Reference: Hazardous Waste Unlined Pits Licence Review Roche Ireland Ltd - P0012-05

URS Schematic Hydrogeological Cross Section Through Landfill Cells H2,1,3,4, Reference EO’H/COR, Job No. 33748-024-447, Figure 4, August 2004

Title		SCHEMATIC HYDROGEOLOGICAL CROSS SECTION THROUGH LANDFILL CELLS H2, 1, 3 & 4	
Location		CLARECASTLE, CO CLARE	
Client		ROCHE IRELAND	
App'd	Reference	Date	AUG 2004
TI App'd	Job No.	Scale	AS SHOWN
		33748-024-447	
URS		FIGURE 4

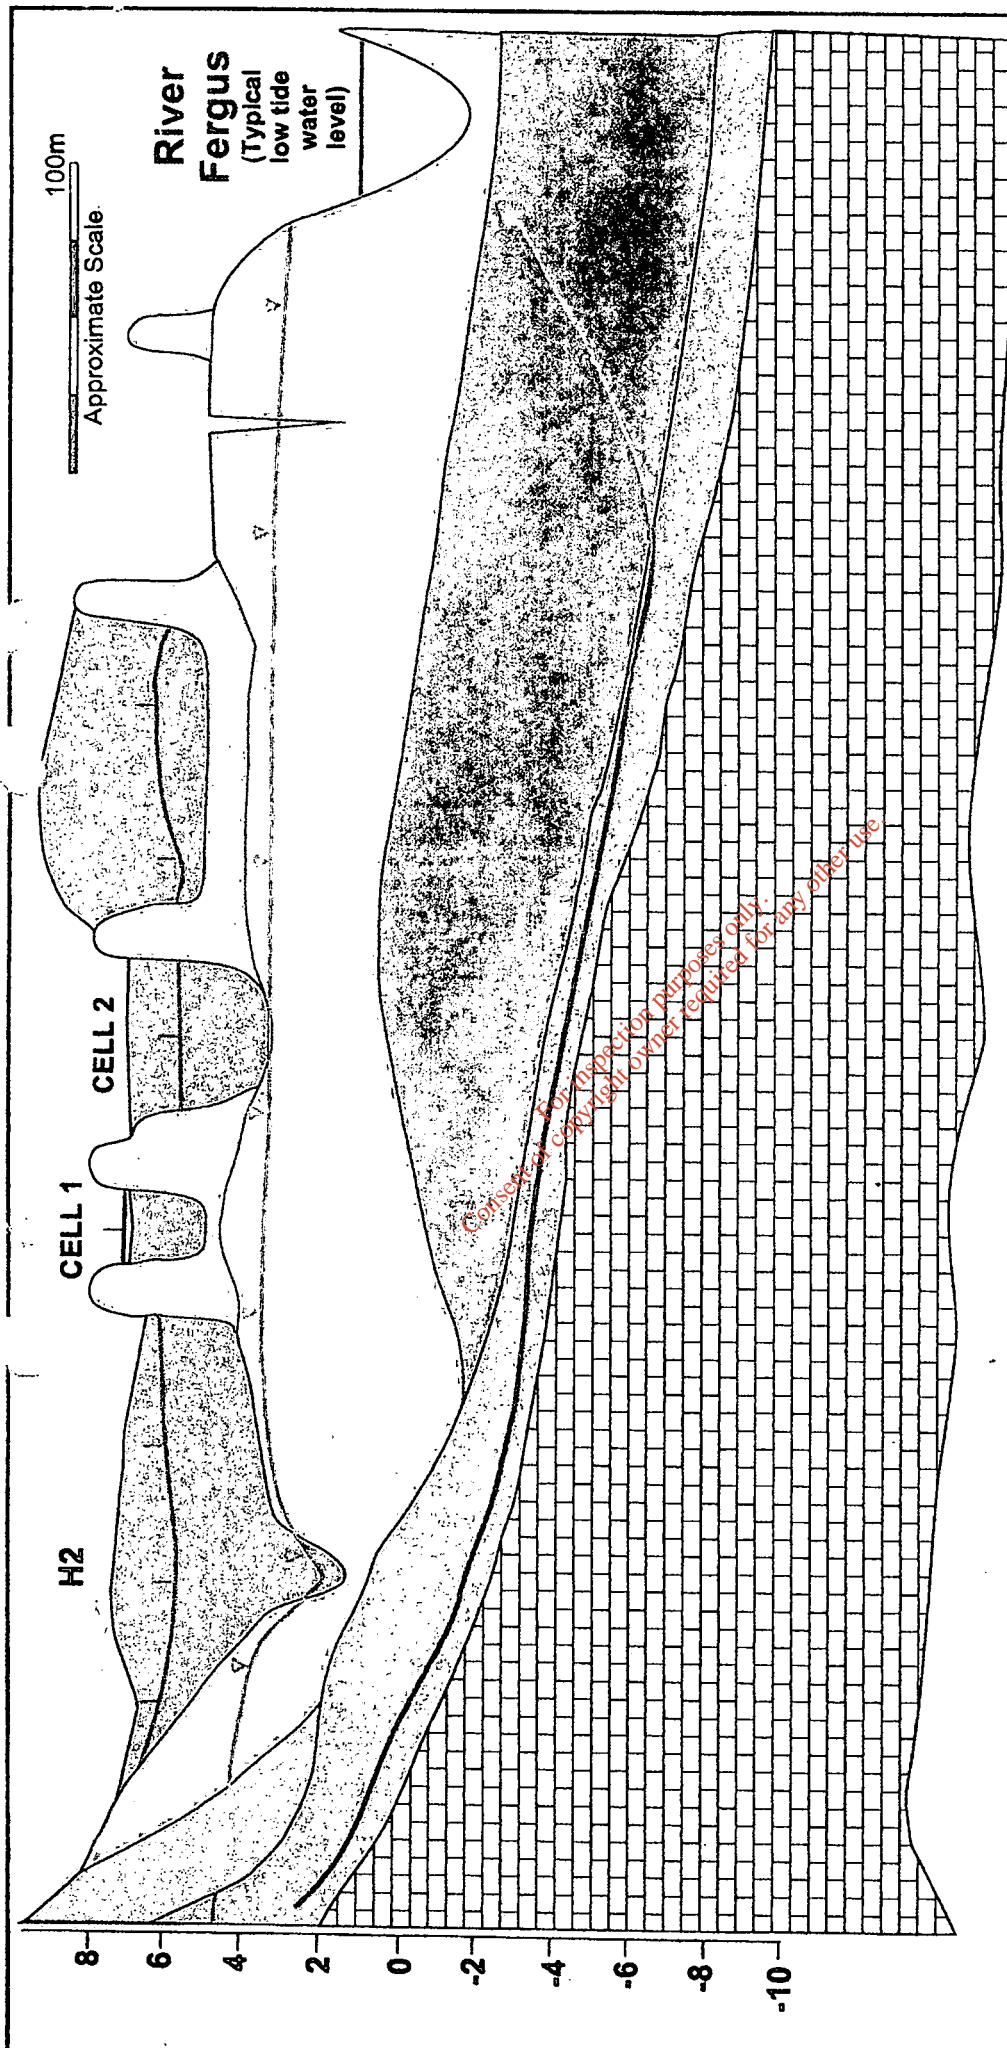
In the interests of the health and safety of members of the public, competitors and safety crews who will be using the River Fergus on the day, it is prudent to draw your attention to the H2 unlined hazardous waste pit and specifically to sections as described by Roche Ireland Ltd own consultants :

Schematic Hydrogeological Cross Section Through Landfill Cells H2,1,3 & 4.

The waste in the H2 area was deposited in unlined pits (up to 3.4m deep), with no facilities for leachate interception and collection. In some areas the wastes are emplaced below the water table (the water table was 0.85 to 2.59m below the well casing in surrounding monitoring wells in October 2004).

“Capping of the H2 area to reduce rainfall infiltration is considered to be of limited benefit, as the chemical/process waste in some areas is emplaced below the water table and there is through- flow of shallow groundwater through the waste, driven by natural gradients due to the hillside to the west of the H2 area.
